FALLS ROAD (MD 189)

Attachment 7

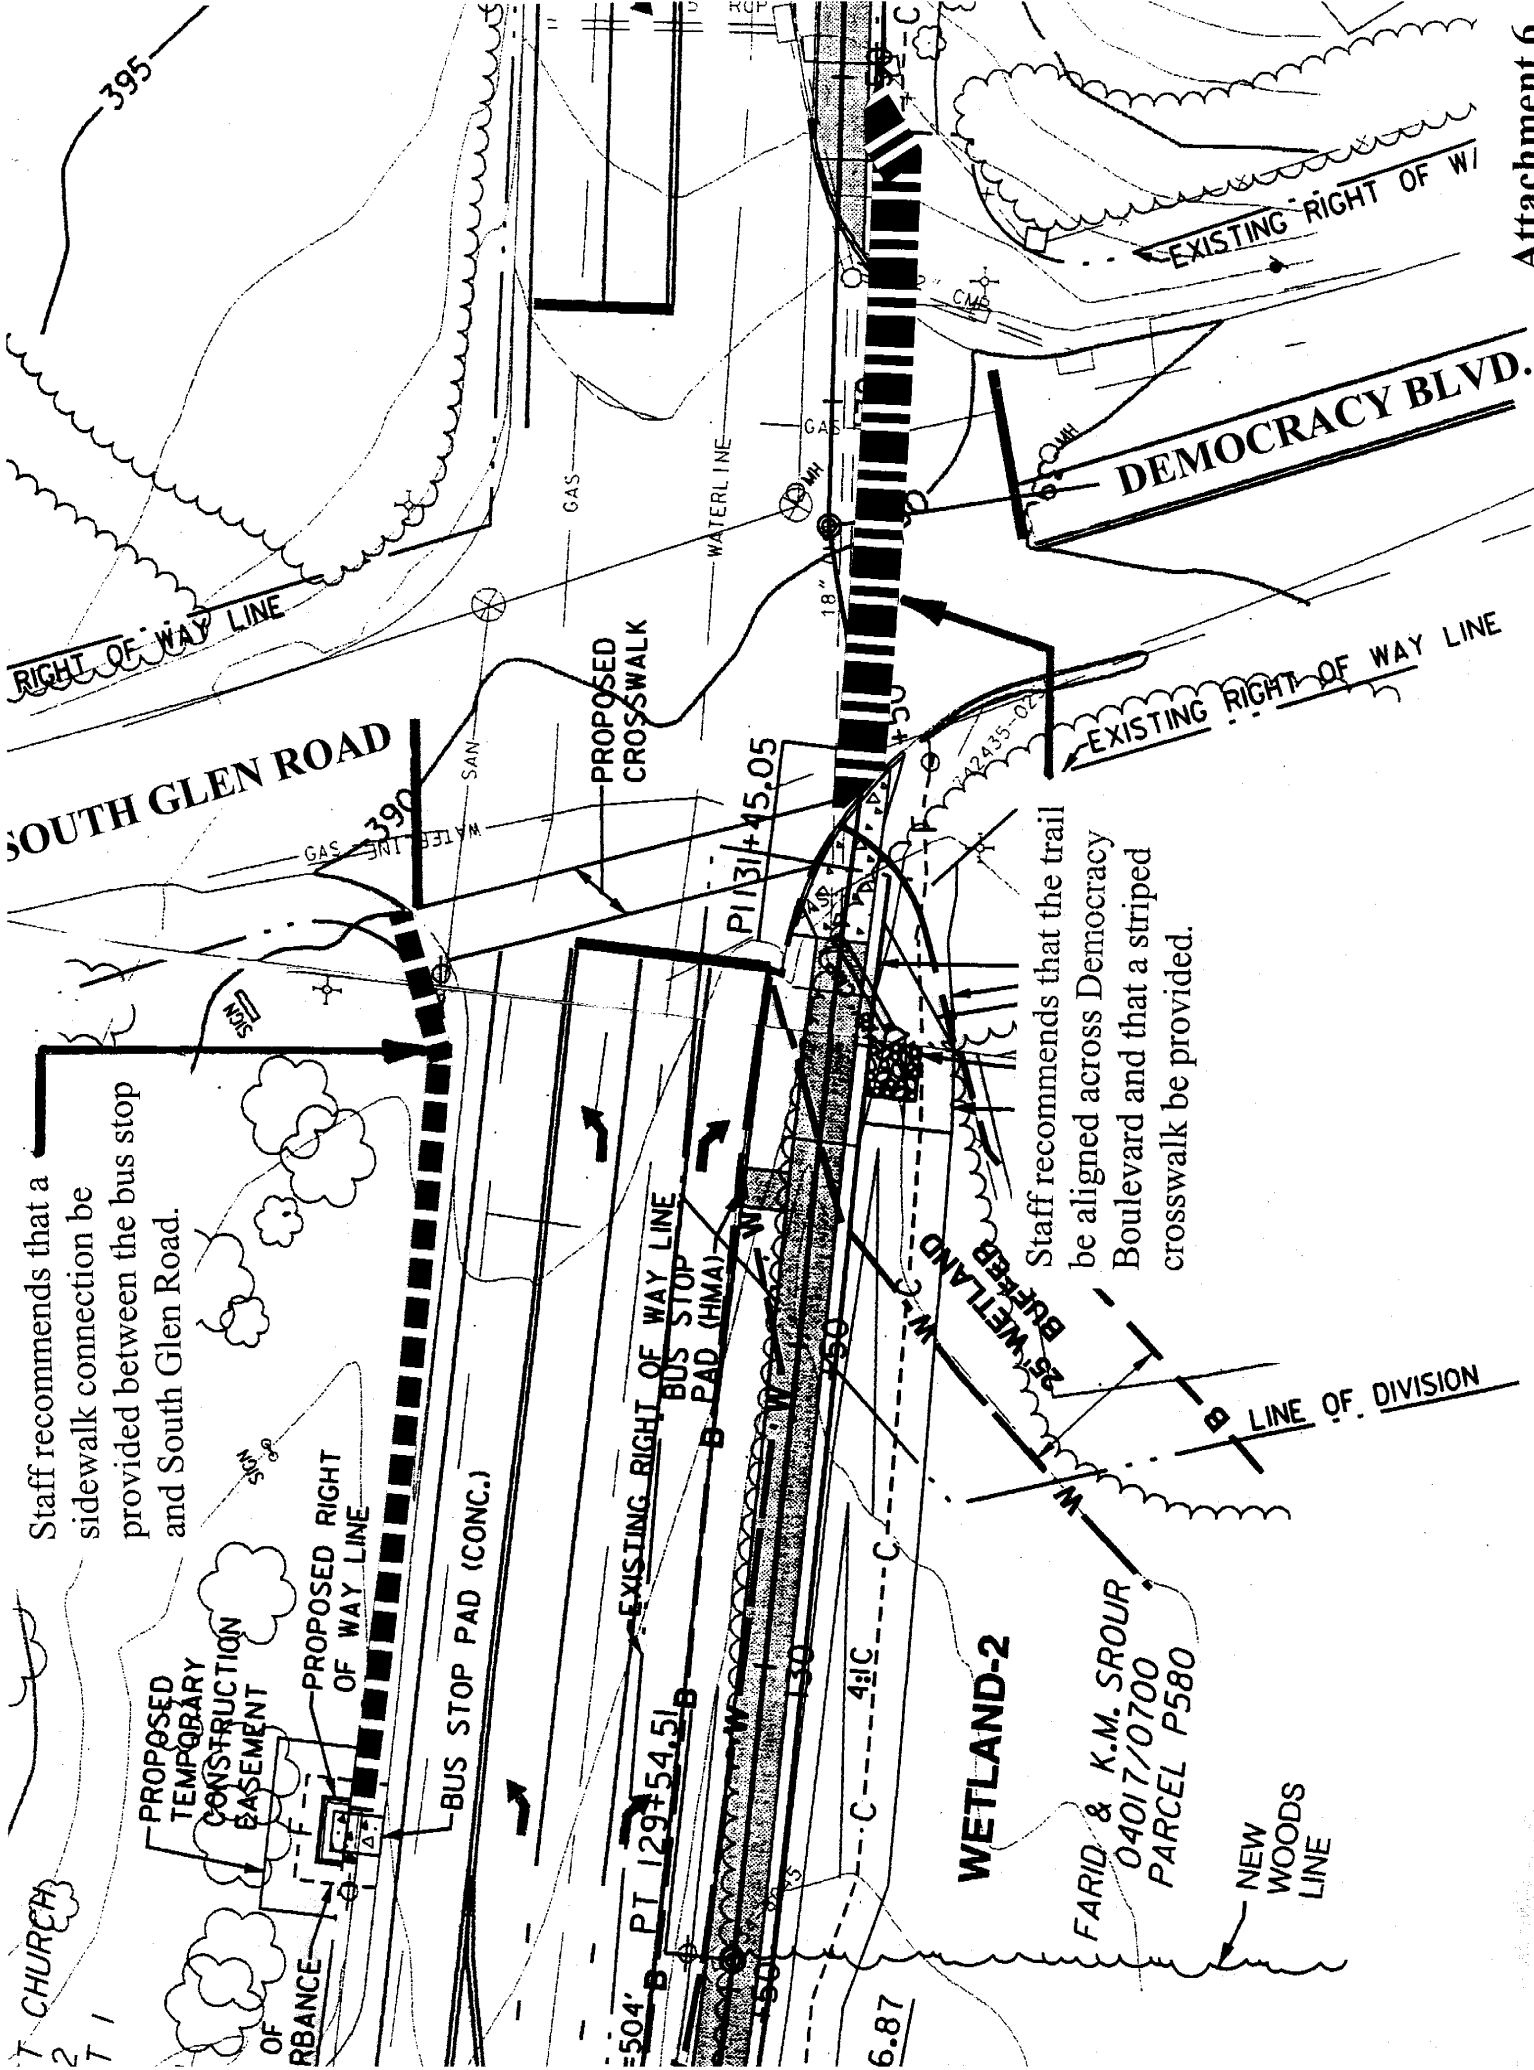
Staff recommends that a sidewalk connection be provided between the bus stop and South Glen Road.

Staff recommends that the trail be aligned across Democracy Boulevard and that a striped crosswalk be provided.

Staff recommends that the end of Cranford Drive be realigned.
